Technical information

Product information BMW brake pads 8DB 355 009-271 / 8DB 355 015-391

New allocation of the brake pads

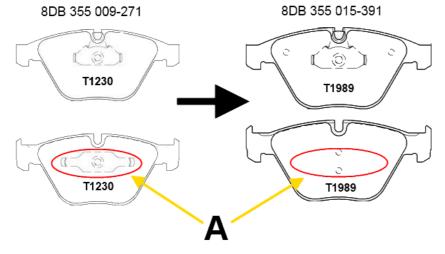
Due to a change in the serial equipment carried out by the vehicle manufacturer BMW, the following article allocation has been adapted as described in the following.

Brake pads 8DB 355 009-271 / T1230 shall still be used for the M models of the 1 series (E82) and 3 series (E90-91).

All other models are now covered by 8DB 355 015-391 / T1989. 8DB 355 015-391 / T1989 can also be retroactively used for all vehicles linked.

The difference between both brake pads is the missing retaining spring (A) on the brake pad 8DB 355 015-391 / T1989 on the fist side.
